KINGSTON STEAM PLANT
SPILLWAY RELOCATION & DIKE "C" SEEPAGE REPAIRS

SCOPE OF WORK

KINGSTON DIKE "C"

COMMENTS ON PROPOSED FIX

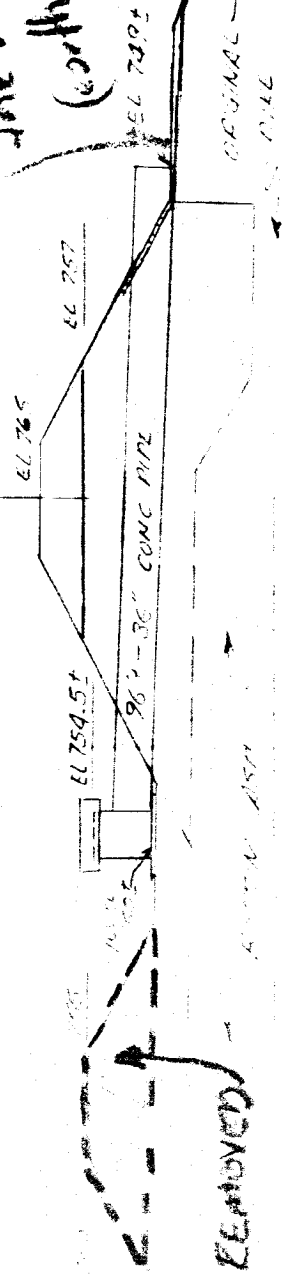
we are going to need
 some thing to confine
 the water. (wall?)
 (orth dike, riprap?)

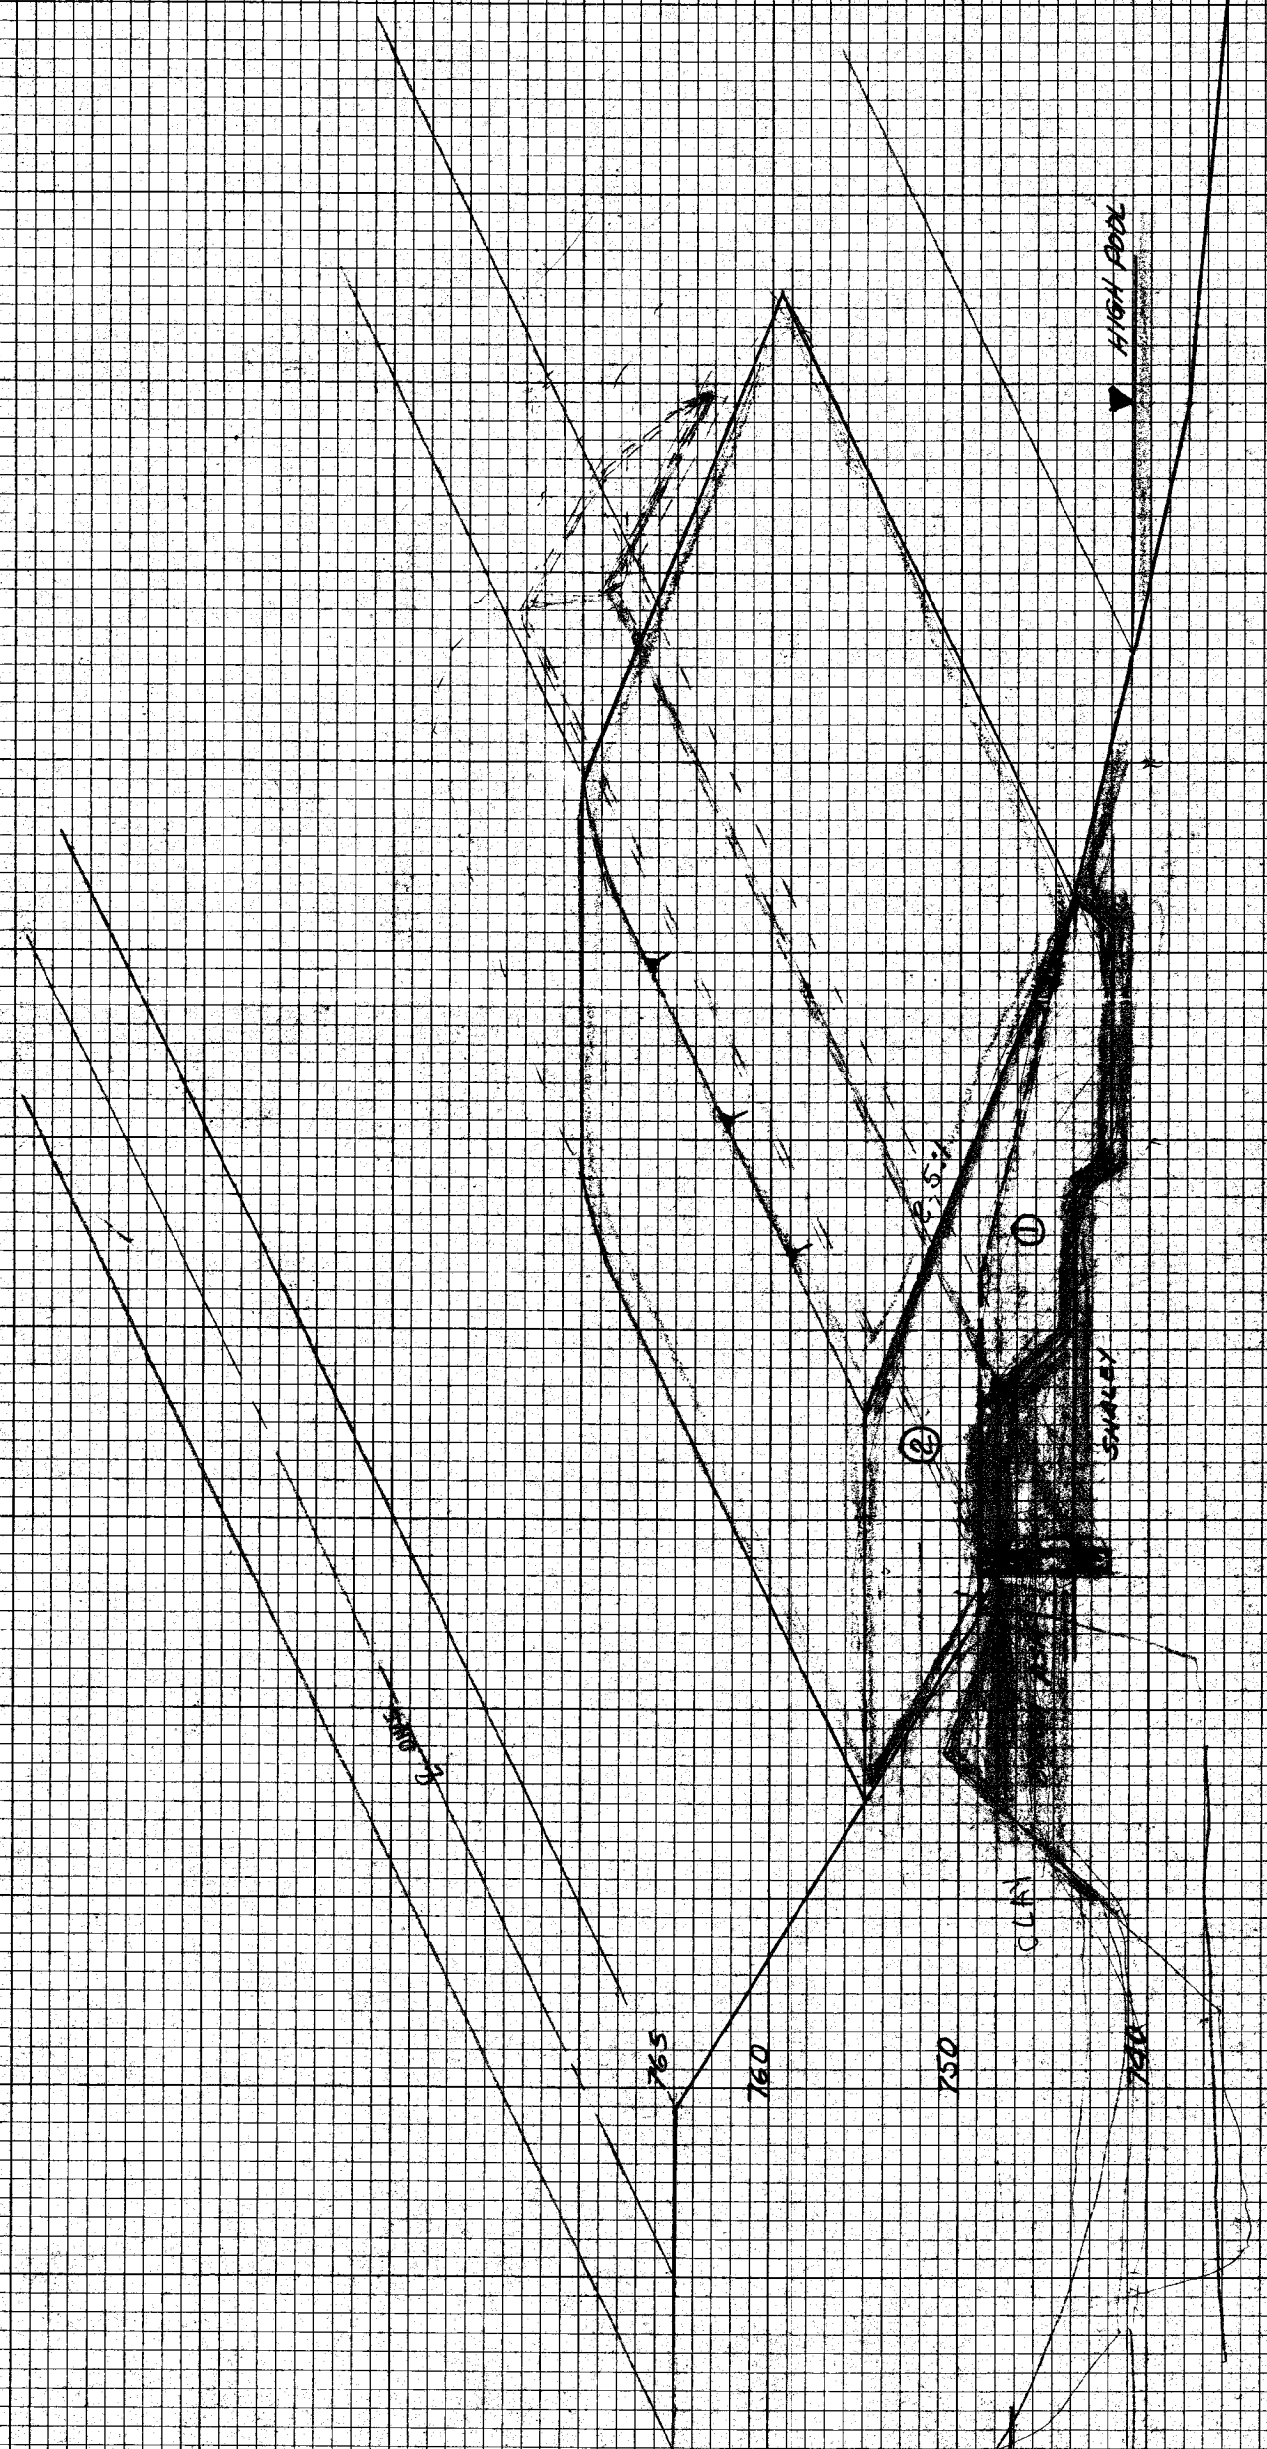
①. MAKE SURE THE TRENCH FOR THE 6" ϕ PERF. PIPE IS NOT LEFT OPEN FOR MORE THAN $\frac{1}{2}$ HOUR. THE MOVEMENT OF THE WATER MAY CAUSE A COLLAPSE AND UNKNOWN STABILITY.

②. AT STAGE ④ OF THE FIX, THE COMPACTION OF THE SOIL SHOULD BE BY SOIL RAMMER OR BACKFILL TAMPER NOT BY BACKHOE.

We agree in principle with your Concept. Pls let us review your final plans + notes. cmt
